Re: Supporting information for the PER and IESC responses for the Vulcan South Project

Date	16 August 2024
Attention	Damien Plucknett
Company	METServe
WRM ref.	1571-34-B2
Subject	Vulcan South – Supporting information for the PER responses

Supporting information and responses to the Independent Expert Scientific Committee Information Request relating to surface water

Figure 2.1 Active water access licences in the vicinity of the Project

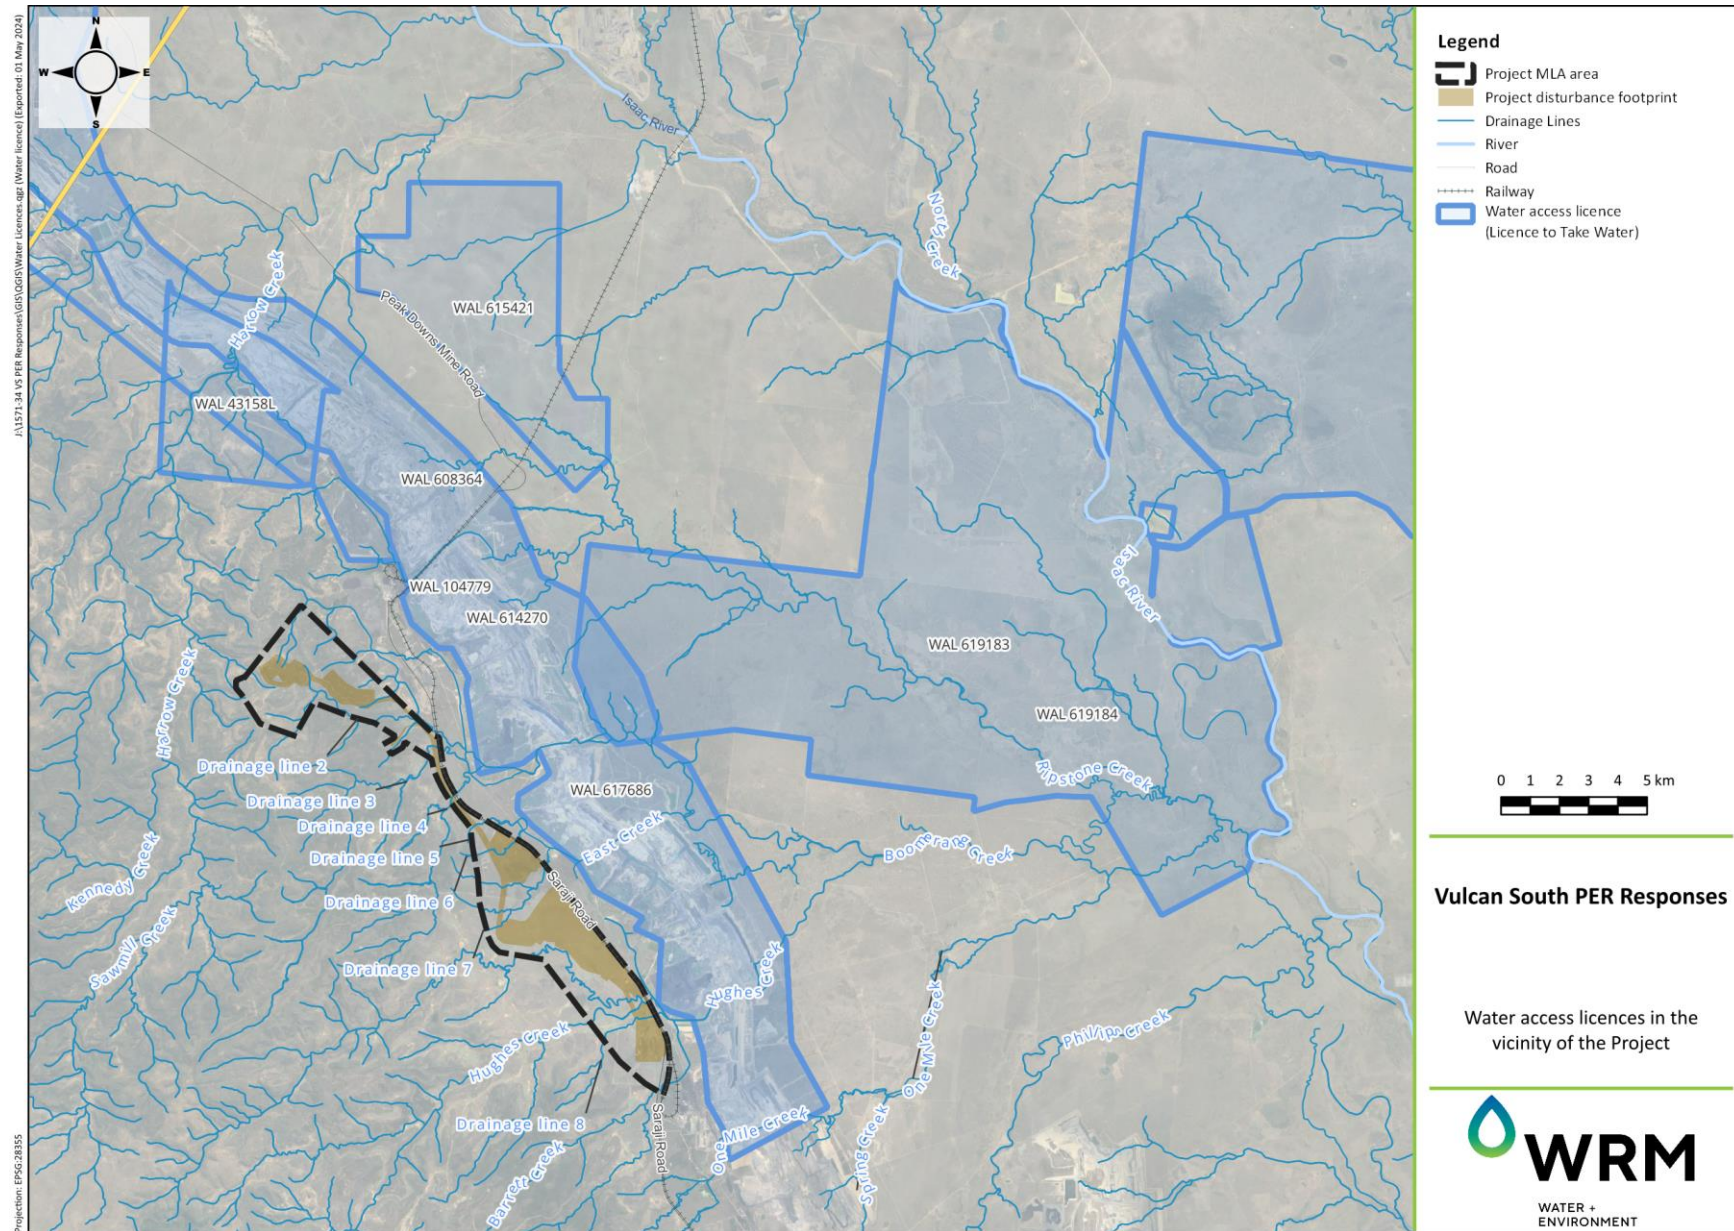
A description of any potential third-party users of water in areas potentially affected by the proposed project, including municipal, agricultural, industrial, recreational and environmental uses of water including:

1. downstream water users accessing surface water via water access licences and basic landholder rights;
2. third-party landholder bores located upstream and downstream of the proposed action, typically installed in the alluvium; and
3. ecosystems that potentially rely on surface water and/or groundwater.

shows the water access licence holders in the vicinity of the Project which may be potentially affected. The active water access licences/licence to take water from waterways that drain through the Project area (Harrow Creek, East Creek, Boomerang Creek, and Hughes Creek) include:

- Moranbah Coal Measures WAL 608364/615421 (Purpose: Dewatering - Underground);
- Boomerang Creek WAL 617686 (Purpose: Site Water Management), Isaac Connors Water Management Area;
- Ripstone Creek WAL 614270 (Purpose: Site Water Management), Isaac Connors Water Management Area;
- Isaac River WAL 619183/619184 (Purpose: Any), Isaac Connors Water Management Area;
- Harrow Creek WAL 43158L (Purpose: Industrial), Isaac Connors Water Management Area;

Figure 3.1 Proposed drainage line diversions

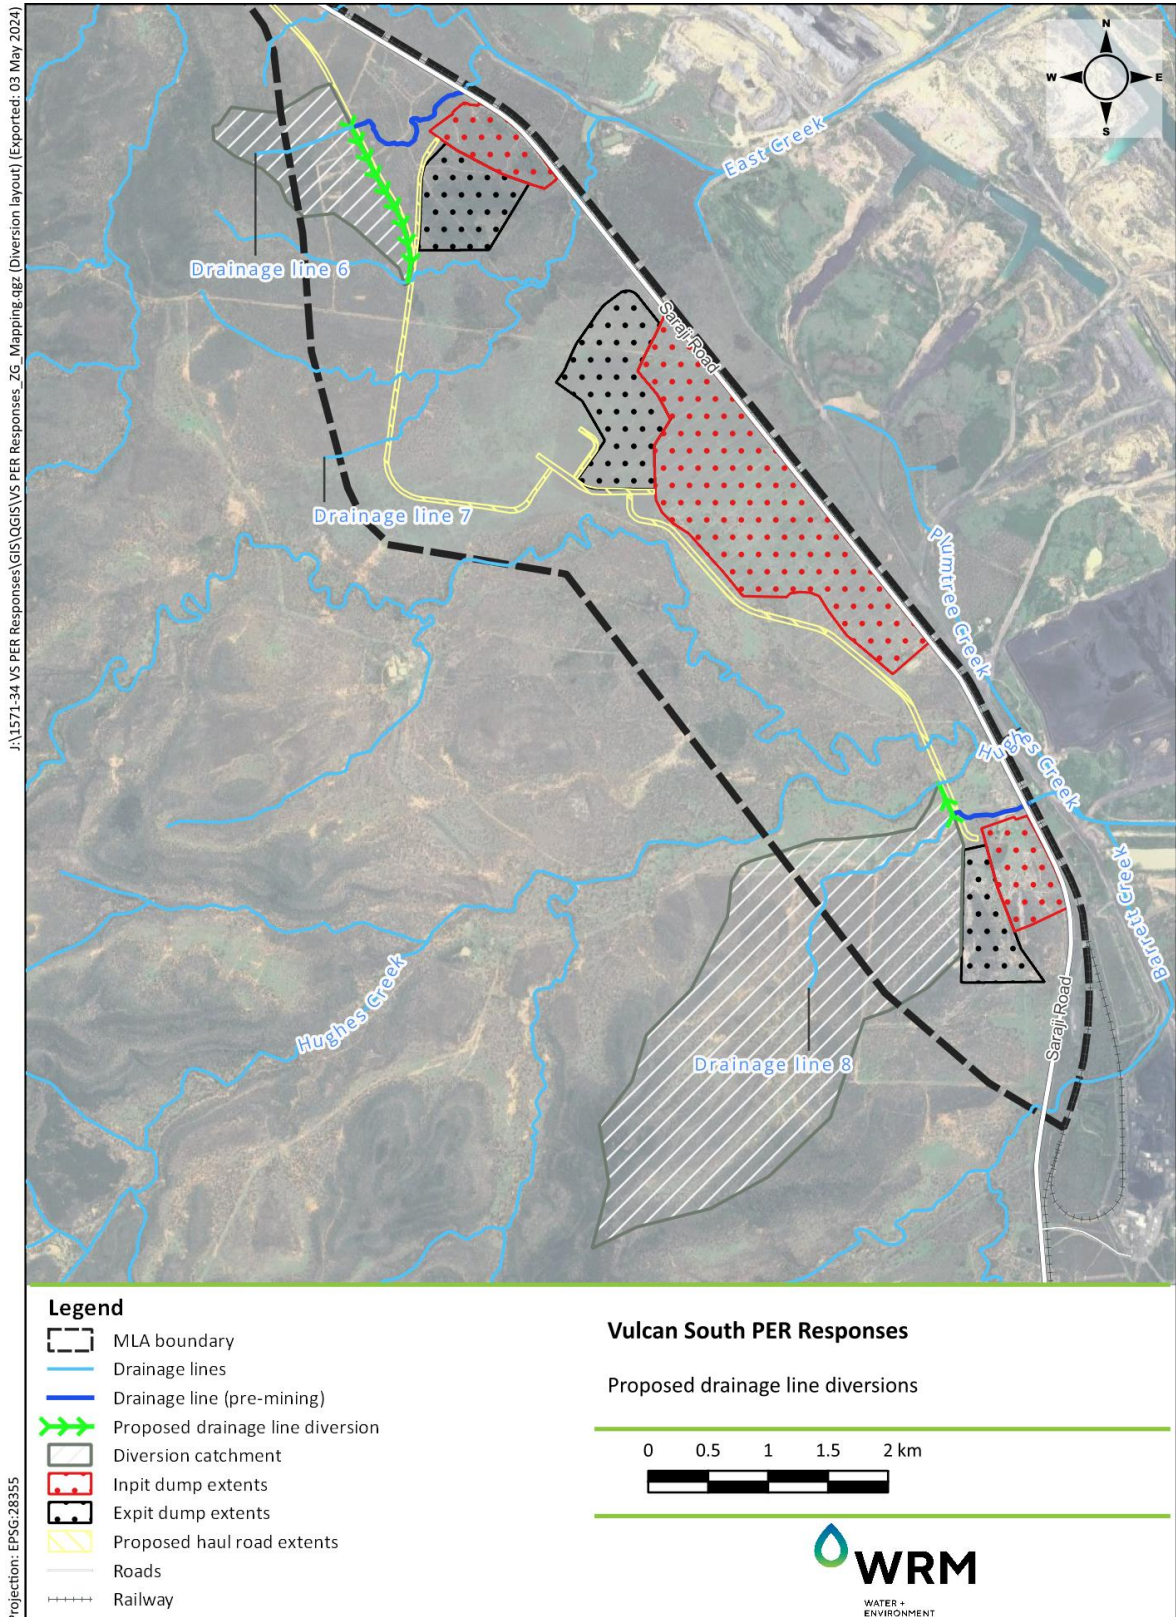
Provide additional information about the design of the proposed diversions for the three headwater streams around the pits.

Figure 3.1 shows the alignments of the temporary drainage diversions proposed during the mining stage of the Project. Table 3.1 summarises the proposed drainage diversions for the Project. Two temporary diversions are proposed:

- Drainage line 6 diversion will divert Drainage line 6 along the proposed haul road upstream of the Vulcan North pit before discharging south into Drainage line 7 at the proposed haul road crossing; and
- Drainage line 8 diversion will divert Drainage line 8 along the proposed haul road upstream of the Vulcan South pit before discharging north into Hughes Creek at the proposed haul road crossing.
